**PN 3903S-6 BUCKLINK™ SLING**  
**6/20/19**

The PN 3903S-6 BuckLink sling has been updated. It is now made with 100% Dyneema® webbing.

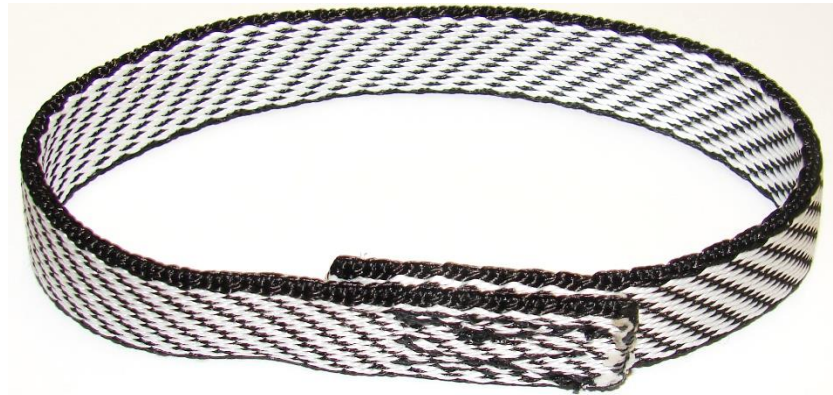
It is stitched using a new smaller ½" x 1 ¼" stitch pattern, making the sling more flexible.

Has new BuckViz™ green wear guard on end of sling and leather label cover to protect the label.

New label has ratings for straight, choked and basket configurations.

MBS. Ratings when New  
Straight: 5,000 lbf.  
Choked: 5,000 lbf.  
Basket: 10,000 lbf.
